ALERT SERVICE BULLETIN

NO. 222U-01-60

MODEL AFFECTED: Model 222U

SUBJECT: UPPER FUEL ENCLOSURE, RIGHT SIDE,
ADDITION OF DRAIN PROVISION

FIGURE 1

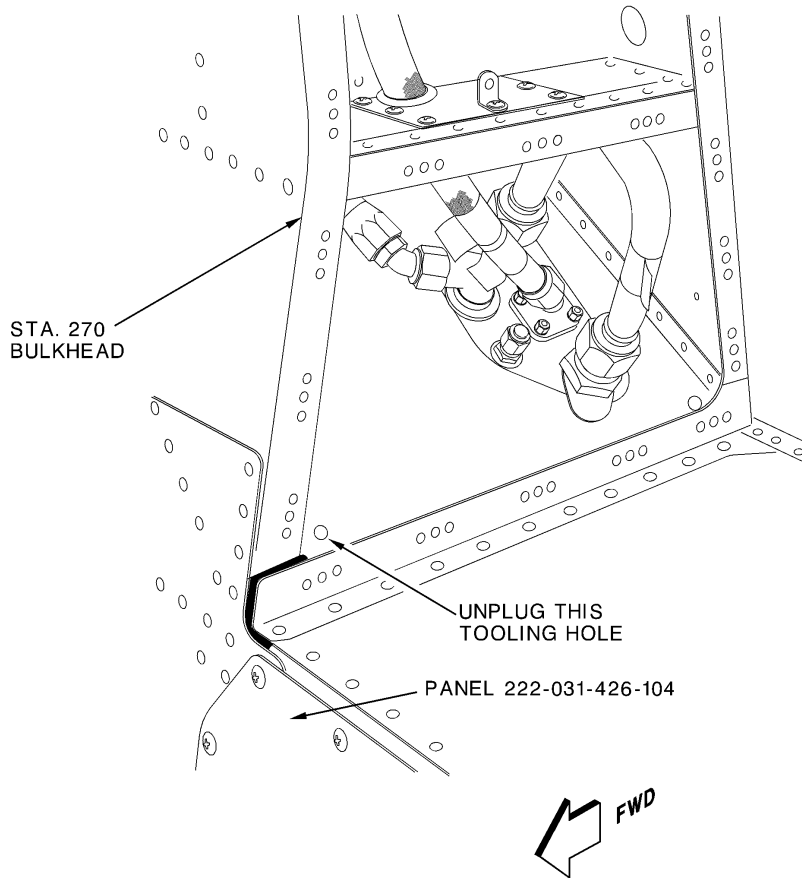
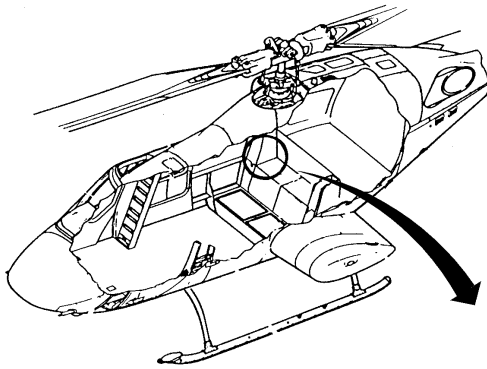
Bell Helicopter Textron has determined that a condition exists that could result in an accumulation of fuel or water in the right hand upper fuel enclosure area located at approximate STA 268.03 to STA 281.87 and W.L. 53.50.

This bulletin provides the procedures to remove the sealant from the existing forward tooling hole located in panel assembly P/N 222-031-470-103 to provide enclosure drainage provision.

Tooling hole is located at approximate STA 271.00, B.L. 22.25, W.L. 54.00 in panel assembly P/N 222-031-470-103

2. Remove fuel cell access panel P/N 222-031-426-104 located on the lower R/H side of STA 270 bulkhead. Refer to Figure 1 and refer to BHT-222U-MM-5, chapter 53.

5. Locate forward tooling hole in panel assembly P/N 222-031-470-103 and unplug hole using a plastic scrapper and a pin punch or a similar object. Refer to Figure 1.
6. Reposition fuel cell upper right hand side into airframe cavity.
7. Install access panel P/N 222-031-426-104 with sealant MIL-S-8784CLB2. Refer to BHT-222U-MM-5, chapter 53.
8. Install the seat cushions and seat backs on the rear passenger seats. Refer to BHT-222U-MM-3, chapter 25.
9. Annotate helicopter records to reflect compliance with this bulletin.
